Proposed extension to ML tunnel (CR-0004)

Nick Walker
ILC@DESY project meeting
23.01.2015

Timing Issue

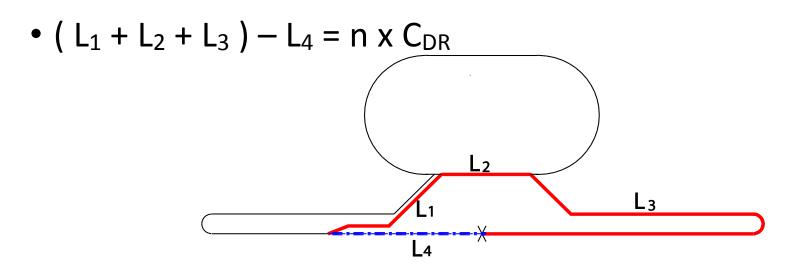
- TDR values give $(L_1 + L_2 + L_3) L_4 = 9 \times C_{DR} + 294 \text{m}$
- It is possible to adjust the value either by
 - Shortening the BDS by ~150m

or by

- Expanding the DR circumference by ~30m
- This will nearly keep the TDR layout
- But no margin for 500GeV, no way to reach 550GeV

Electron Linac

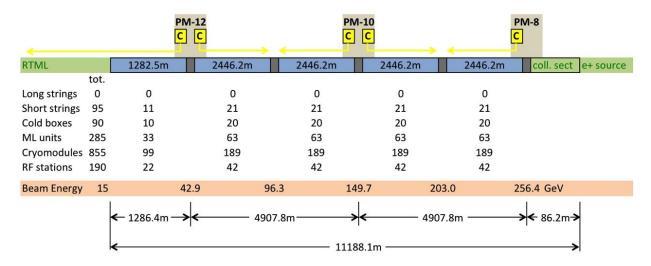
- CR-004 has formally been submitted to CMB
- Proposes ~1.5km extension to both Main Linac tunnels
 - simple warm beam transfer line
- Rationale:
 - Corrects global timing path length for 10×C_{DR}
 - Allows room for extension to main linacs (up to 14%)
 - Facilitates margin for reduced gradient or
 - Higher E_{cm} capability
 - → Guarantee min 500 GeV performance

Vertical Access (shift ML to the North)

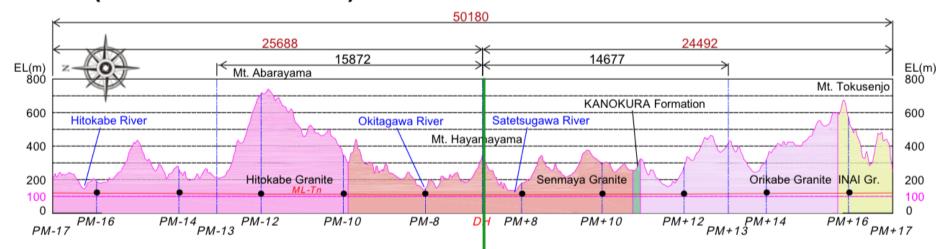
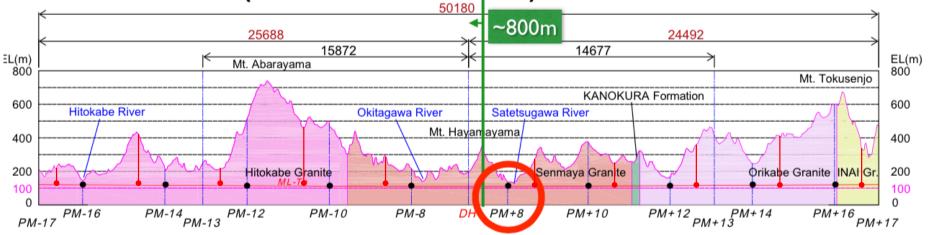
- CMB to form Change Review Panel
 - meeting today
- Request to "attempt cost neutrality"
 - Estimated cost increase ~100 kILCU
 - Impact on horizontal tunnel accesses to be accessed
- Attempt to conclude by April LC meeting (KEK)
 - Milestone for fixing tunnel length and CFS layout.
